SR/CR A1A PEDESTRIAN SAFETY & MOBILITY STUDY

PEDESTRIAN / BICYCLE SAFETY REVIEW

Focus Area G / S 23rd Street to S 11th Street and at the Beverly Beach Camptown RV Resort (Flagler Beach)

Project Title: Focus Area G Pedestrian/Bicycle Safety Field Review

Figure 18

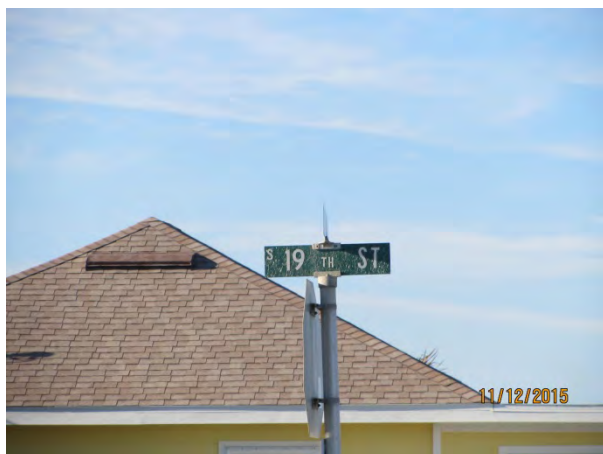
The study team also observed numerous signs along the corridor, both in the number of signs along the corridor and the applicability/location of some of the signs. For example, **Figure 18** displays a pedestrian warning sign near a private beach access with little pedestrian crossing volume while other public beach access points have no warning signs.

In the near term, consider replacing street name signage (**D3-1**) with new retro-reflective signs using applicable font size following the guidance provided in section 2D-43 of the 2009 *Manual on Uniform Traffic Control Devices (MUTCD)*. Table 2D-2 specifies 6" letter height on post mounted street signs at intersections along two-lane roadways. The street signs closer to SR 100 were recently upgraded to have 6" letter height with a decorative border so consider replacing the street signs along the study corridor with the same signage type for consistency.

Also during the next resurfacing project, a signage study/plan for the study corridor to evaluate the amount of signage, applicability, retro-reflectivity, and location along the study corridor. This signage study/plan should include replacing the older signs with signs meeting current standards.
